MODIFICATION TO DRB22-0859 APPROVAL FOR SINGLE FAMILY RESIDENCE

DRB FILE No. DRB25-1105

4,5,6 STAR ISLAND DRIVE

PURPOSE OF MODIFICATION:
SEEKING DRB APPROVAL OF 34 FT MAXIMUM BUILDING HEIGHT AS OF RIGHT UNDER CURRENT MIAMI BEACH RESILIENCY CODE

POST FILING MODIFICATION TO NORTH ELEVATION

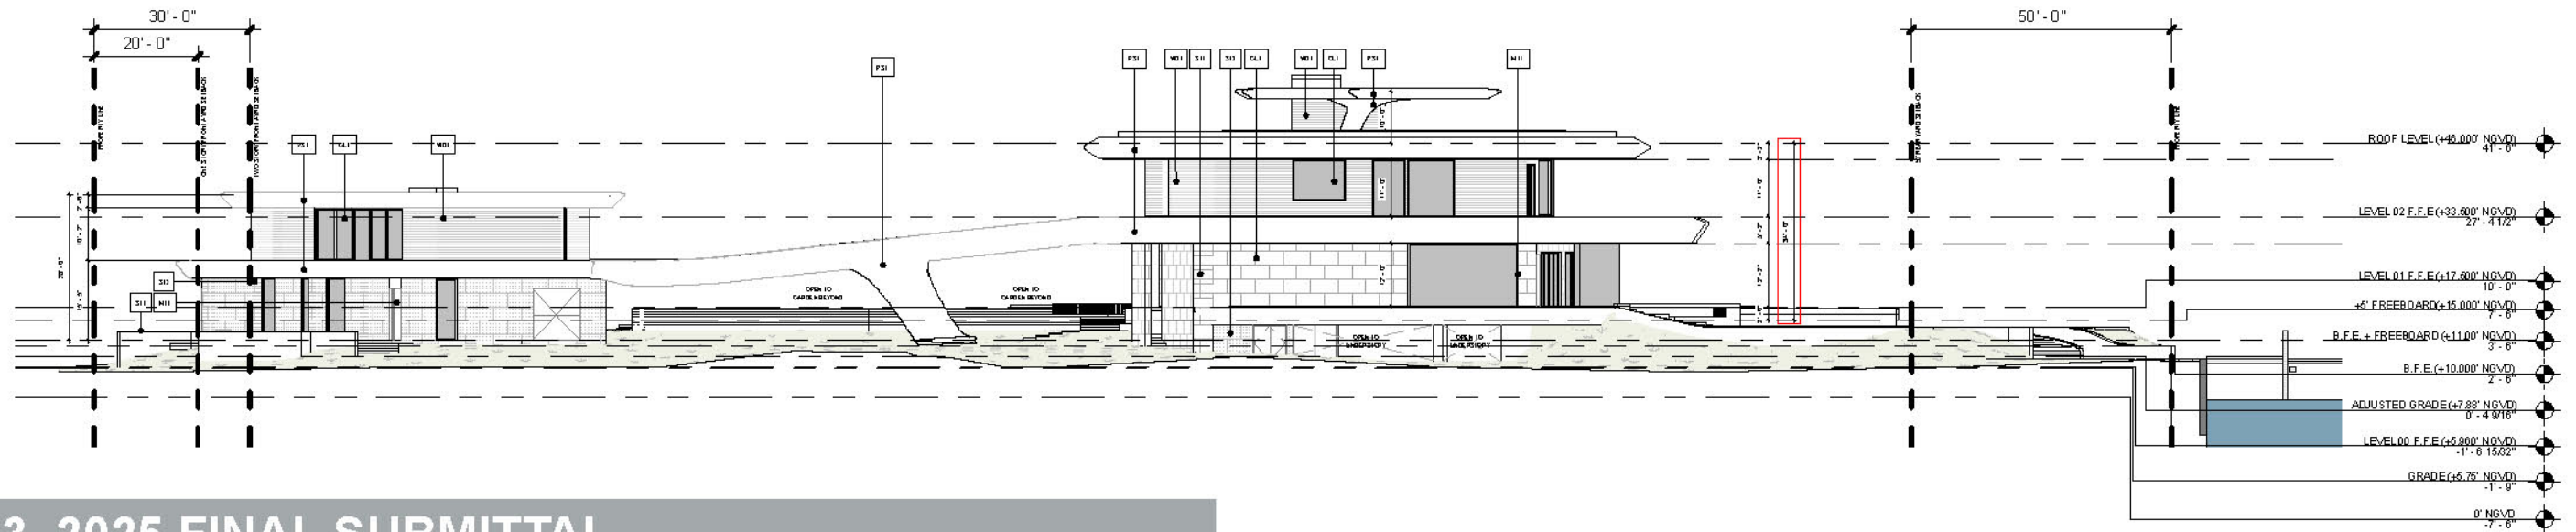
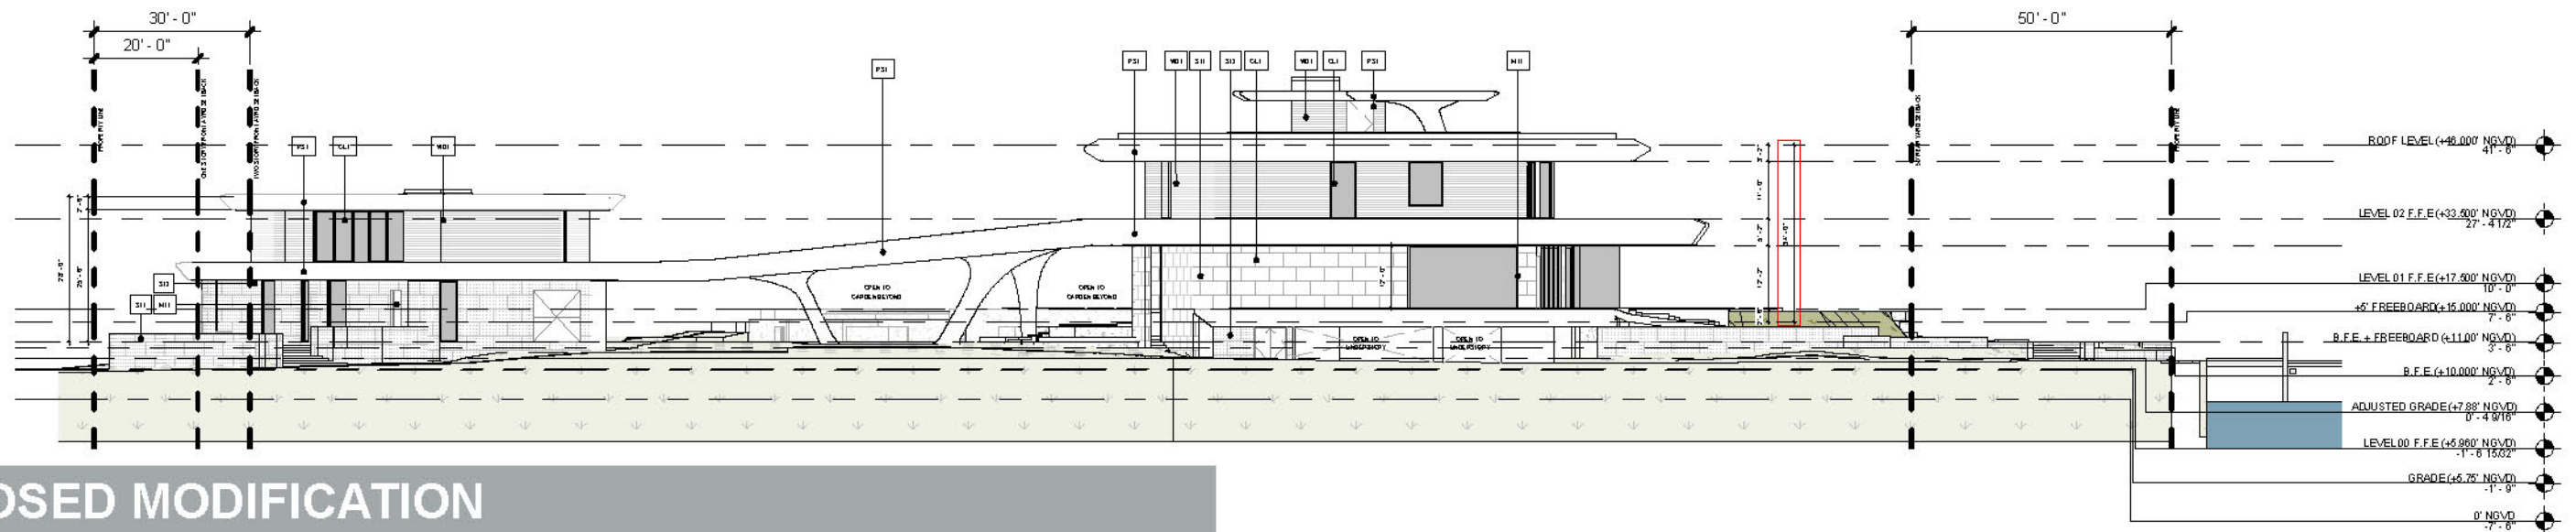
PROPOSED MODIFICATION

POST FILING MODIFICATION TO SOUTH ELEVATION

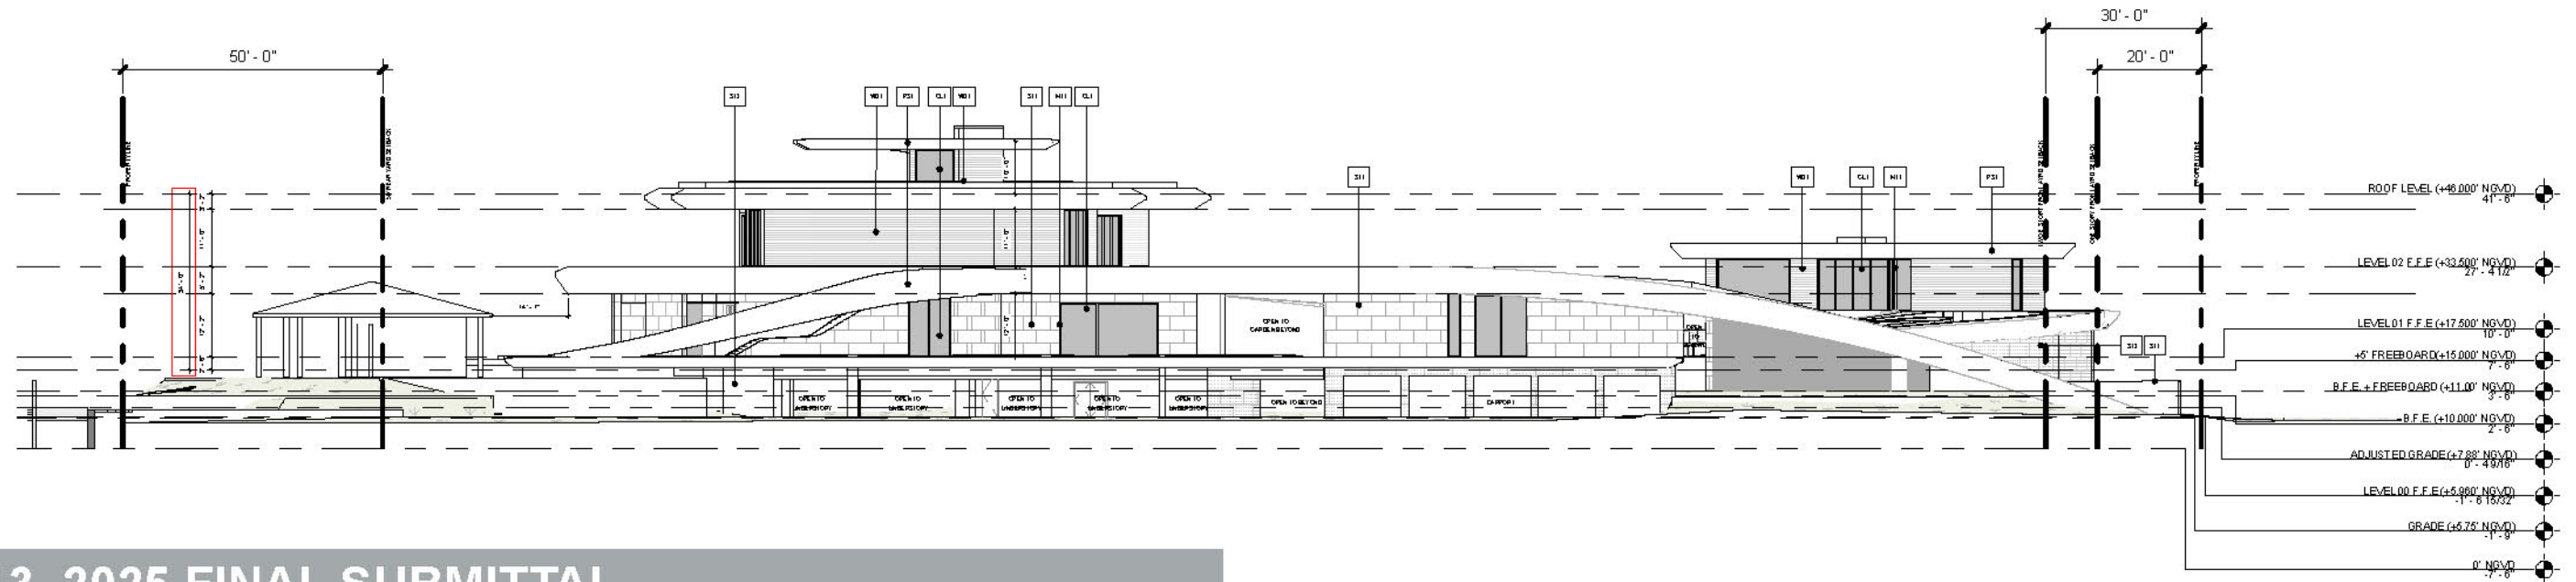
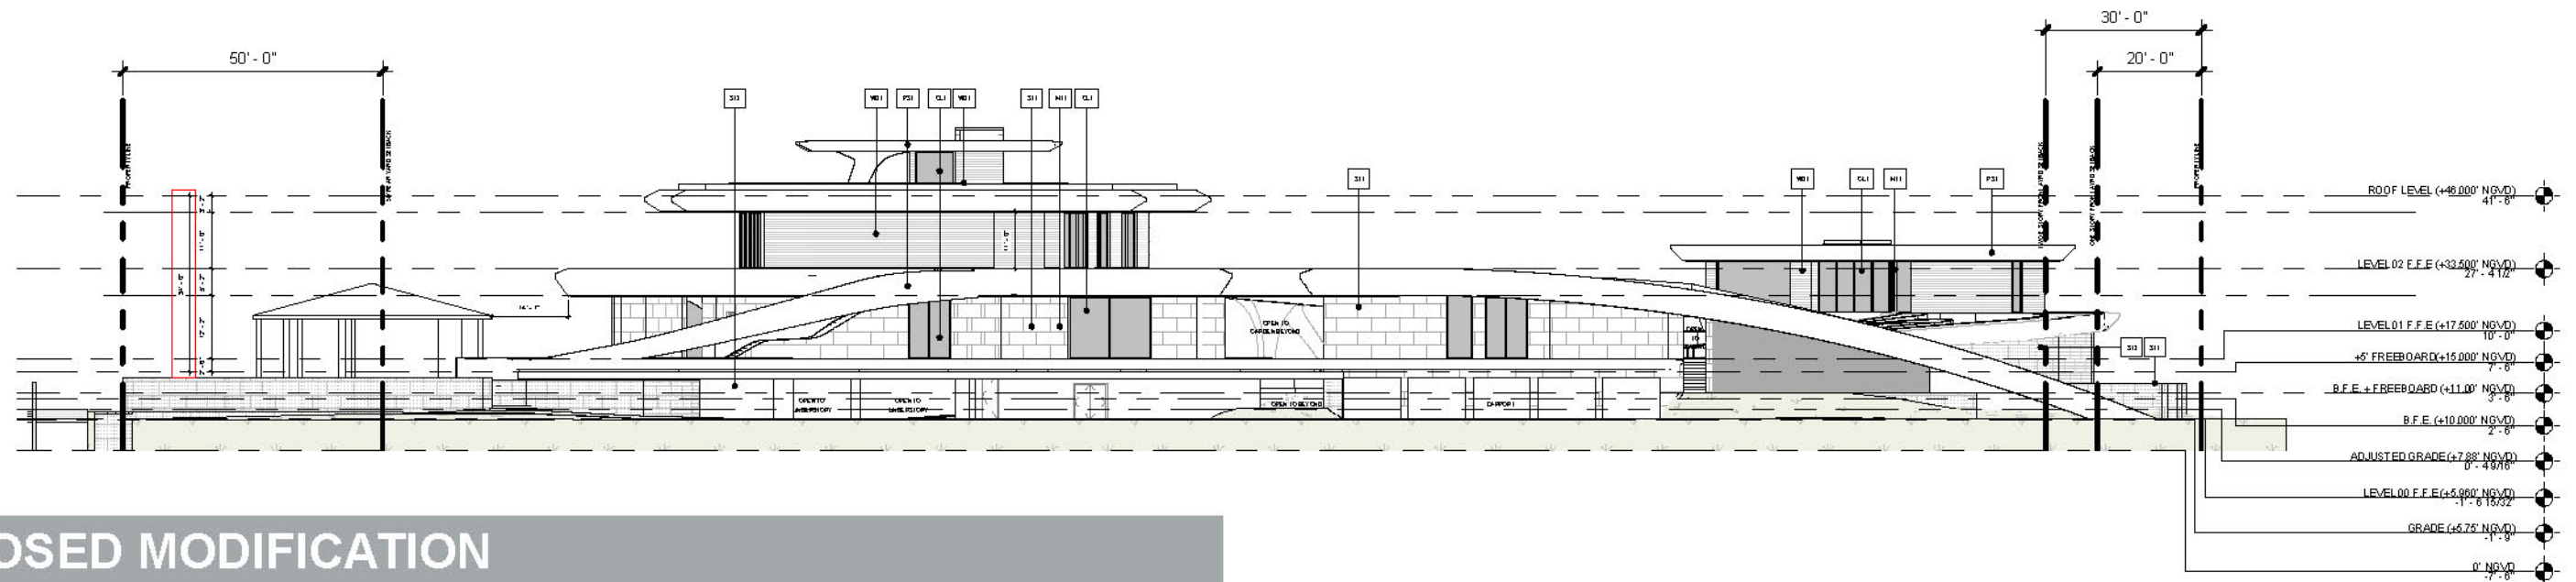
PROPOSED MODIFICATION

POST FILING MODIFICATION TO LOT COVERAGE

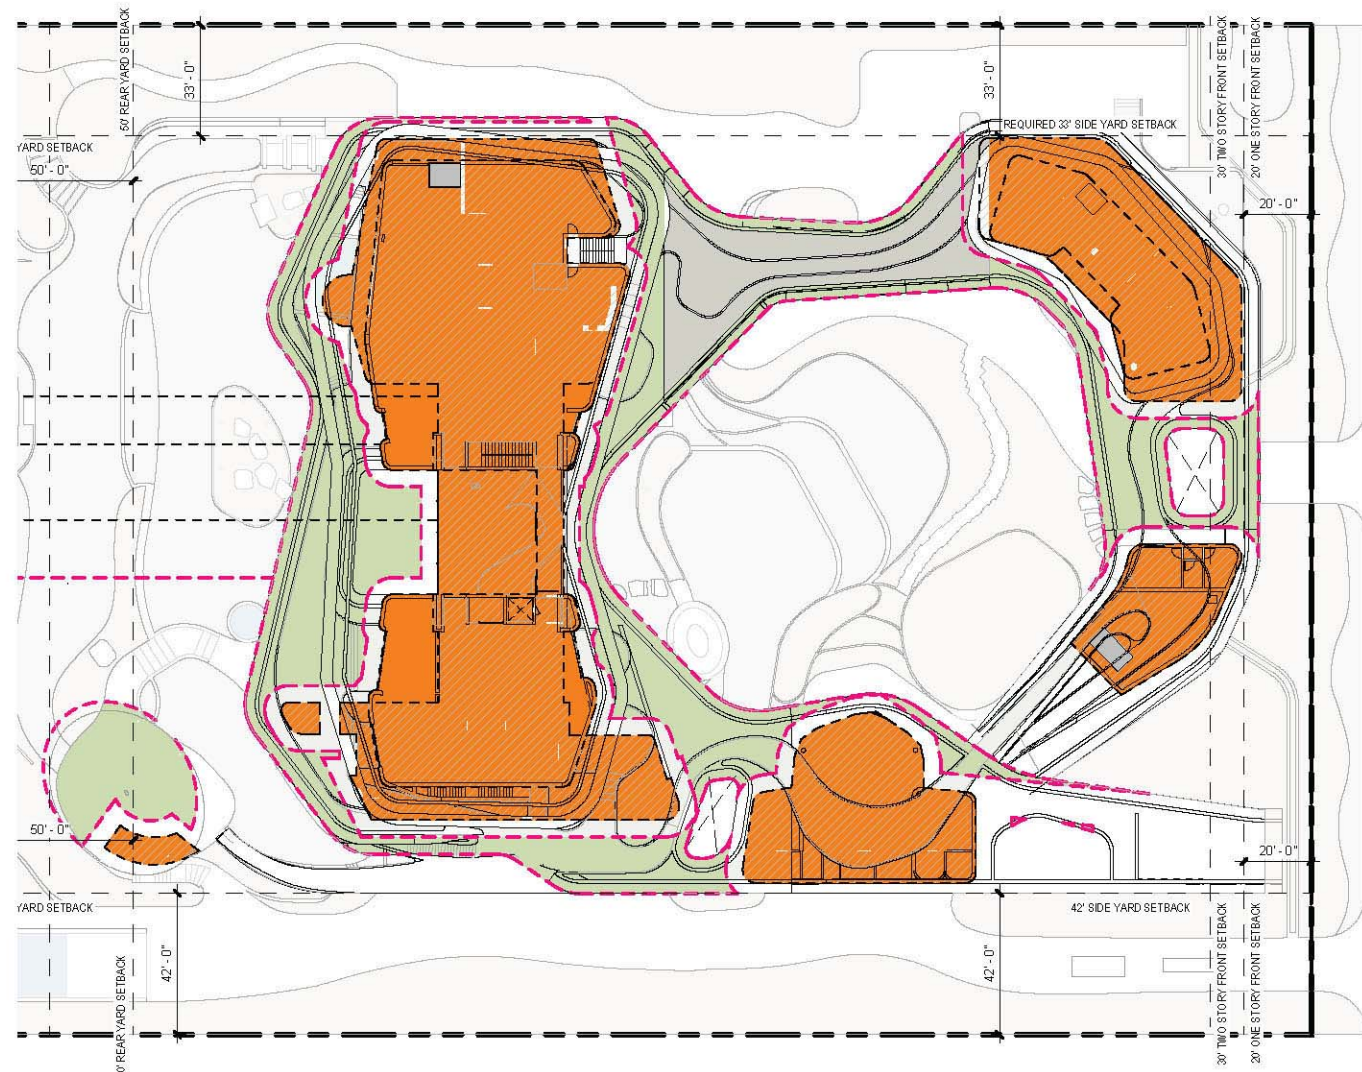
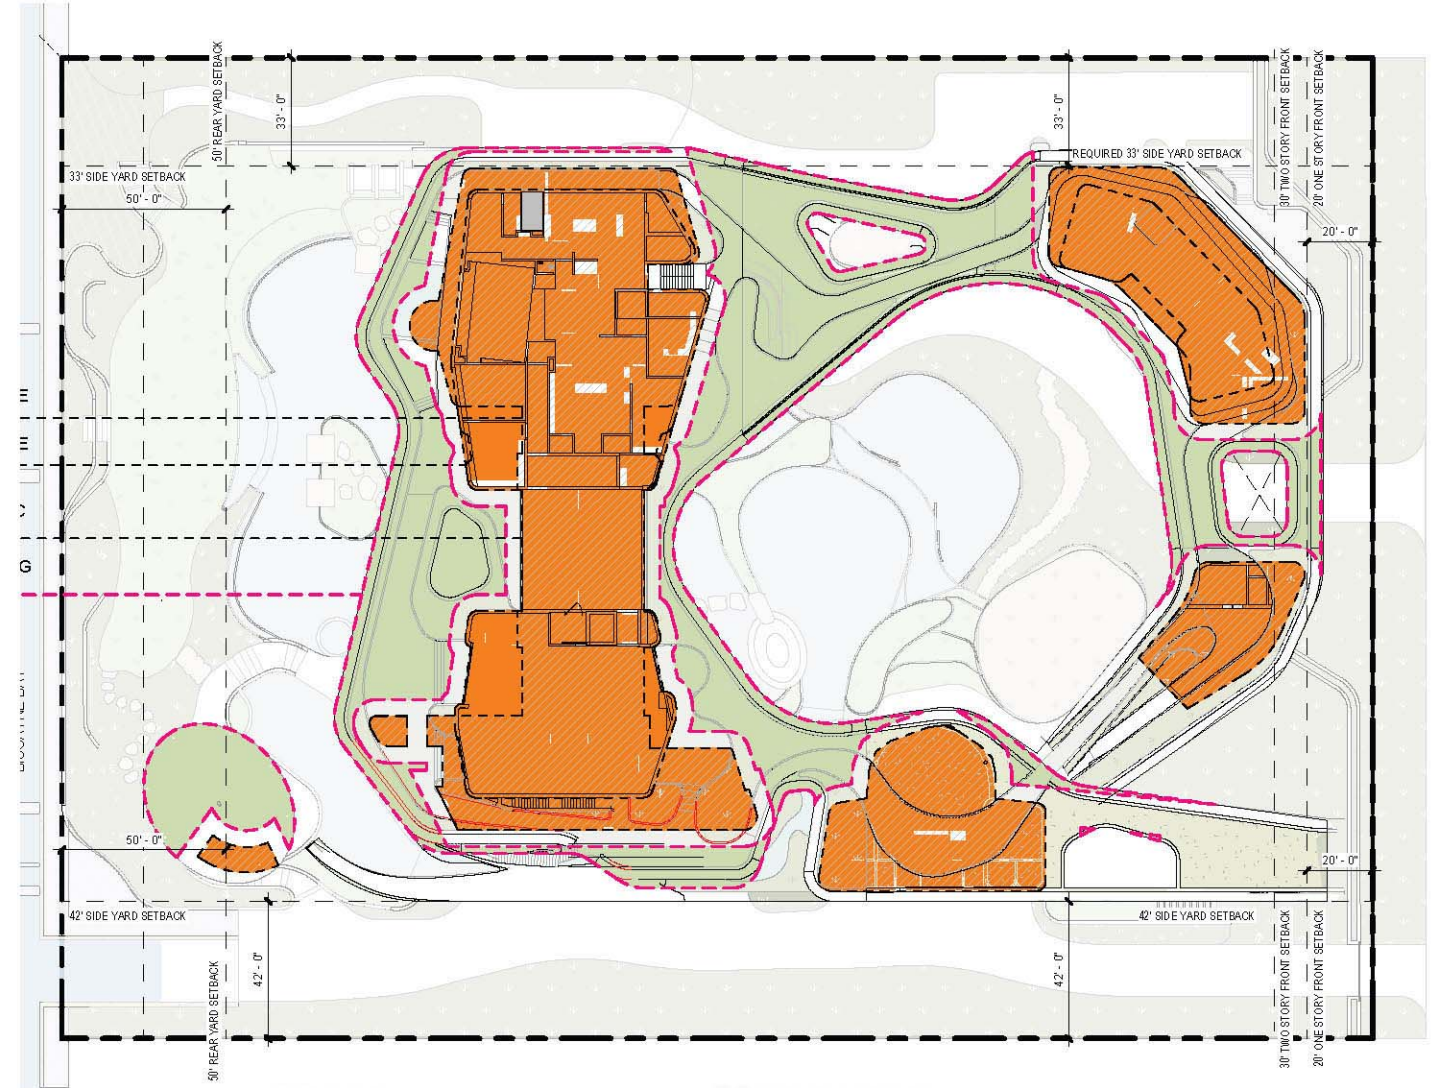
PROPOSED LOT COVERAGE:
UNDER AC: 19,873 SF (LVL 01) + 1,290 SF (LVL 02*) = 21,163 SF
ROOF COVERAGE > 5': 14,582 SF

PROPOSED LOT COVERAGE:
UNDER AC: 19,853 SF (LVL 01) + 1,290 SF (LVL 02*) = 21,143 SF
ROOF COVERAGE > 5': 14,602 SF

SUBMISSION	SQUARE FOOTAGE
2022	35,884 SF
FINAL 07/13/25	35,745 SF
LATEST	35,745 SF
